# Access Compliance Report

## Public Rights-of-Way

Intersection ID: 20287	Main Street: SOUTH_BV	Cross Street: WICKER_DR	Location: NE
ADA ID: C390CEF16A93	Ramp Type: PerpDiag	Initial Pass/Fail: Fail	Overall Compliance: No
		Severity Score: 10

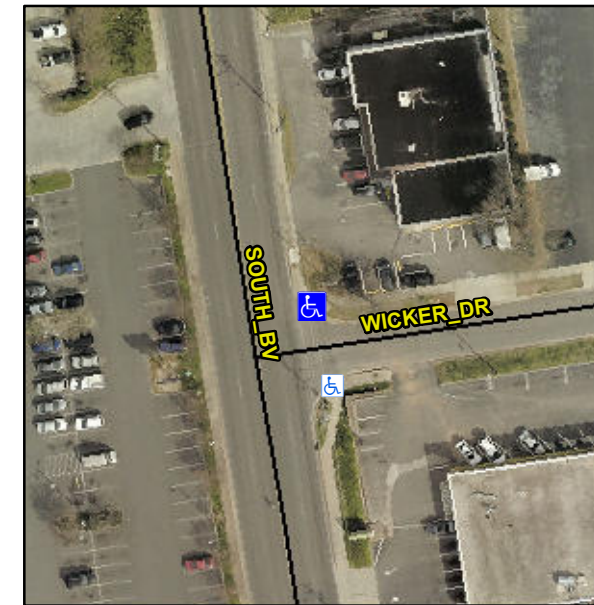
**Not Found, R304.5.1, R304.5.3**

Compliance	Description	Data	Compliance	Description	Data
N/A	Ramp Length (in)	98.0	Yes	Ramp Slope (%)	5.3
No	Ramp Width (in)	47.0	No	Ramp XSlope (%)	2.3
N/A	Flare Type LT	N/A	N/A	Flare Type RT	N/A
N/A	Flare Slope LT (%)	N/A	N/A	Flare Slope RT (%)	N/A
N/A	Flare Traversable LT?	N/A	N/A	Flare Traversable RT?	N/A
N/A	Landing Length (in)	N/A	N/A	DWS Provided?	N/A
N/A	Landing Width (in)	N/A	N/A	DWS Contrast?	N/A
N/A	Landing Slope (%)	N/A	N/A	DWS Length (in)	N/A
N/A	Landing X Slope (%)	N/A	N/A	DWS Full Width?	N/A
N/A	Landing Curb? (Y/N)	N/A	N/A	DWS Offset (in)	N/A
N/A	Shared Landing?	N/A			
N/A	Gutter Ponding?	N/A	N/A	Gutter Slope (%)	N/A
N/A	Gutter Lip Ht (in)	N/A	N/A	Gutter X Slope (%)	N/A
N/A	Painted X Walk1?	No	N/A	Painted X Walk2?	No
	X Walk 1 Direction	To W		X Walk 2 Direction	To S
N/A	X Walk 1 Width (in)	N/A	N/A	X Walk 2 Width (in)	N/A
	X Walk 1 Slope (%)	1.5		X Walk 2 Slope (%)	1.1
	X Walk 1 X Slope (%)	0.2		X Walk 2 X Slope (%)	0.5

**Remove & Replace Curb Ramp With Two New Directional Ramps or Equivalent.**
